Japan Comments Part 2 for
Battery Durability GTR
@EVE45

25. March.2021

ECU estimation accuracy of SOH

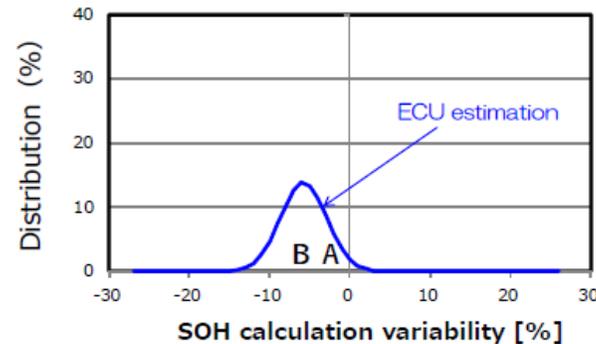
There is measurement variability, the results of the 99 percentile determination varies by 13.4% from the measured capacity, according to the figure presented at EVE 34 -15 .

In the previous model, SOH in the in-vehicle ECU is lower than the measured true value by 5% on average and varies in a range of about 15%. Accumulating design tolerance further increases the variation.

Technically meaningless requirements (All underlined sentences, including the SB portion) should be deleted.
